**Change Request**

**Number:** 41  
**Date:** 1/30/20  
**Job:** 19050 Bonner Springs Govt Services  
**Phone:**

**Description:** RFI 124 City Hall: Masonry Parapet @ Existing Building

**Subject:** City Hall: Masonry Parapet @ Existing Building

**Drawing:** B3/A525  
**Cost Impact:** TBD

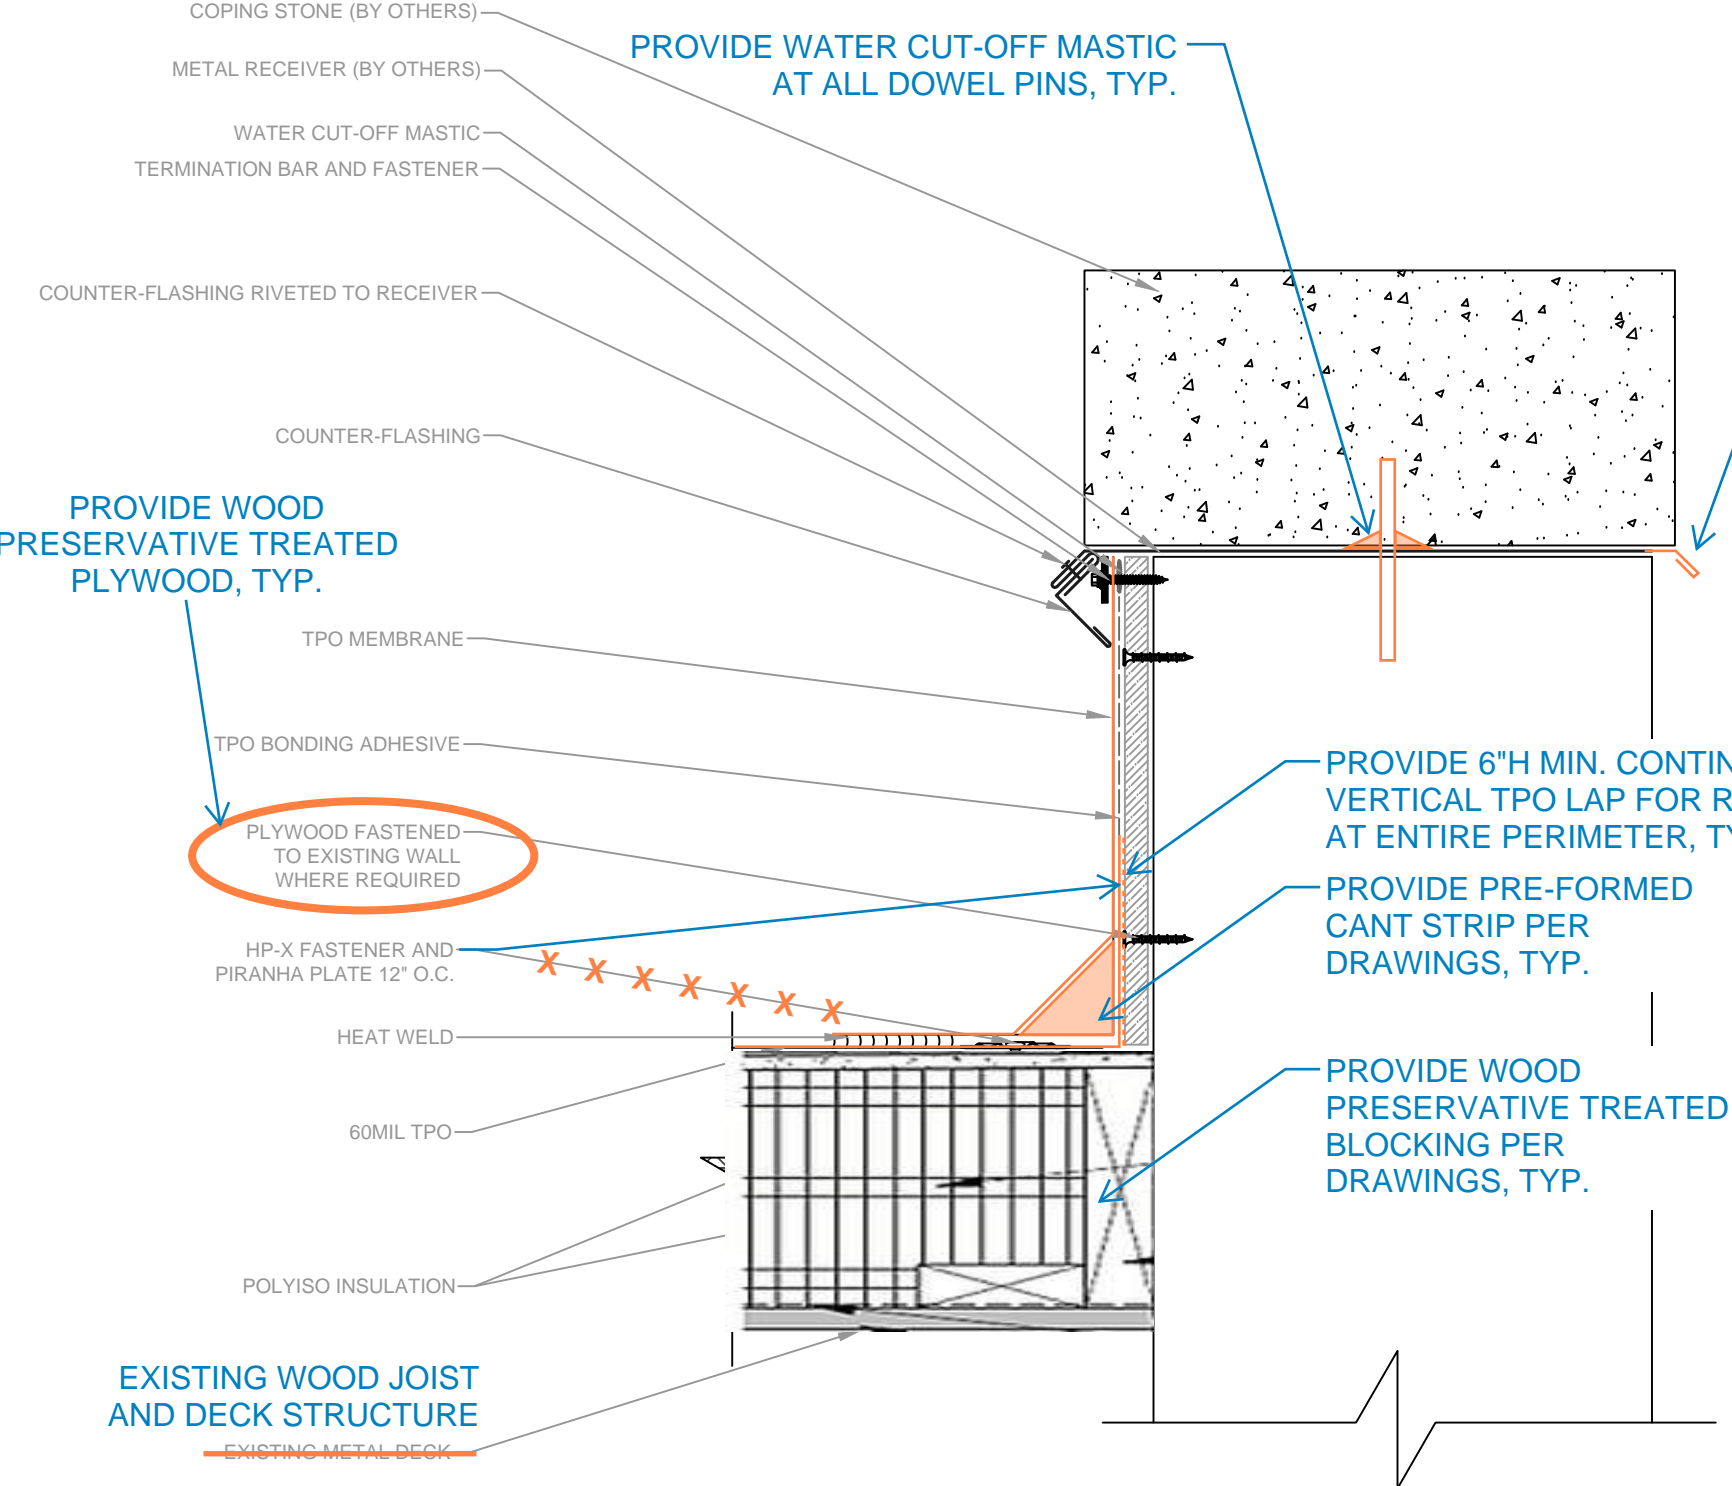
**Request:**  
Please see attachments.

SEE ATTACHED MARK-UPS TO ROOF PARAPET DETAIL SUBMITTED FOR DIRECTION.

**PROVIDE 1/2" OVERLAP PER DRAWINGS, TYP.**

**PROVIDE WOOD PRESERVATIVE TREATED PLYWOOD, TYP.**

**PROVIDE 6"H MIN. CONTINUOUS VERTICAL TPO LAP FOR REDUNDANCY AT ENTIRE PERIMETER, TYP.**

**PROVIDE PRE-FORMED CANT STRIP PER DRAWINGS, TYP.**

**PROVIDE WOOD PRESERVATIVE TREATED BLOCKING PER DRAWINGS, TYP.**

**PLYWOOD FASTENED TO EXISTING WALL WHERE REQUIRED**

**HP-X FASTENER AND PIRANHA PLATE 12" O.C.**

**B3** SECTION DETAIL AT PARAPET - ALTERNATE 1  
**A525** 1 1/2" = 1'-0"

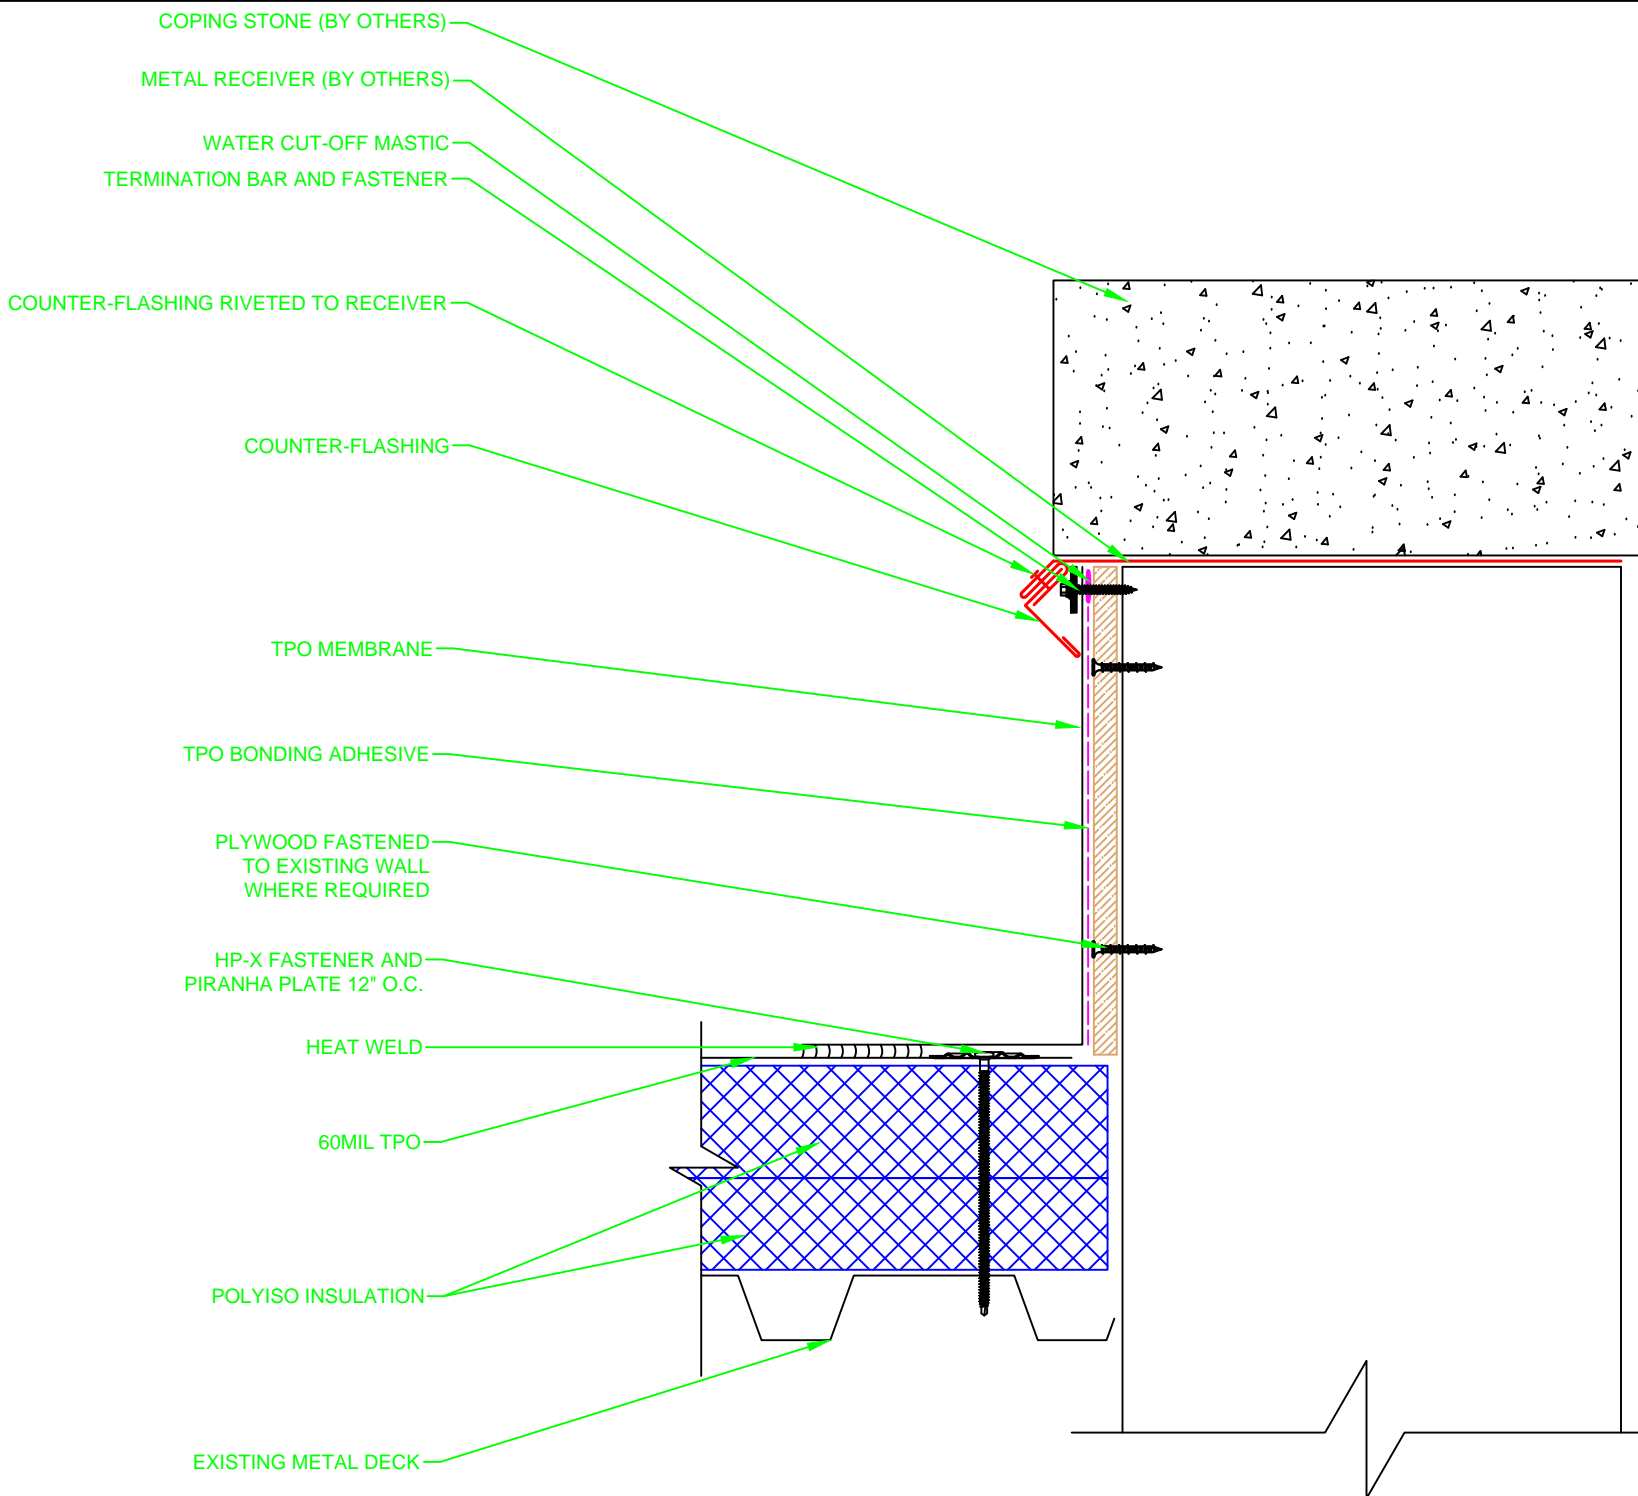
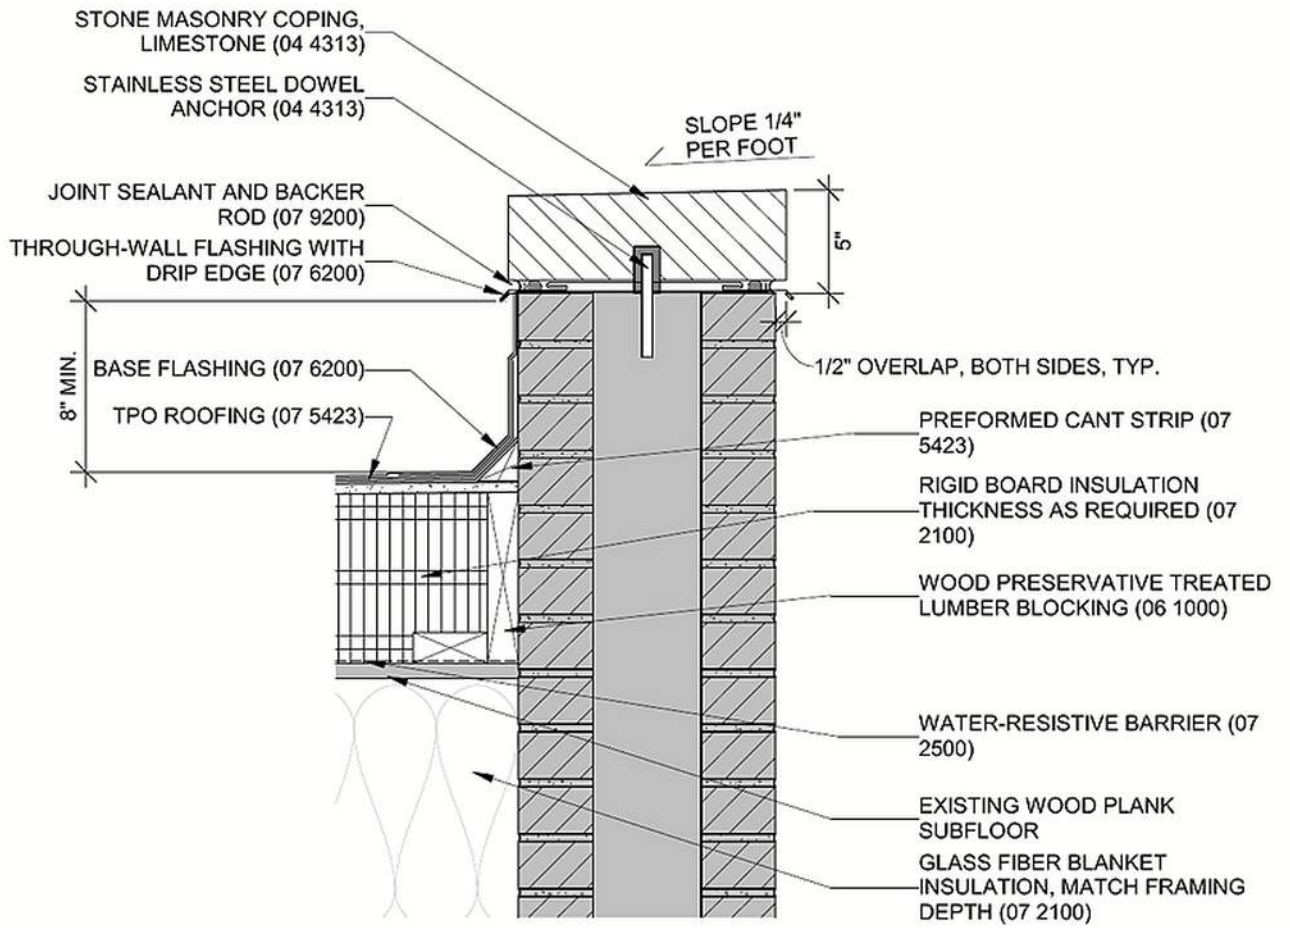
Premier would like to have plywood installed on the interior of the parapet walls for a suitable substrate to properly install our wall flashings. The existing brick is in very poor condition on the inside and is currently not a suitable substrate to adhere our membrane properly.

Currently the membrane is to run up and over the wall and have a historic stone coping installed in lieu of the originally planned metal coping cap. If the membrane is ran up and over the wall there needs to be some sort of termination below the stone coping. Roofing manufactures warranty will stop just below the stone coping. It would be best practice if the stone coping was installed over a piece of metal flashing of some sort that will go from the outside of the wall to the inside with a return leg on the interior of the parapet wall for a counterflashing detail. The counterflashing should cover the roof membrane termination bar entirely. The stone coping installer should have a best practice installation detail similar to the roofing detail. With this counterflashing detail it will also be a better practice for reroofing down the road and able to remove existing counterflashing and termination bar and install new in a similar fashion.
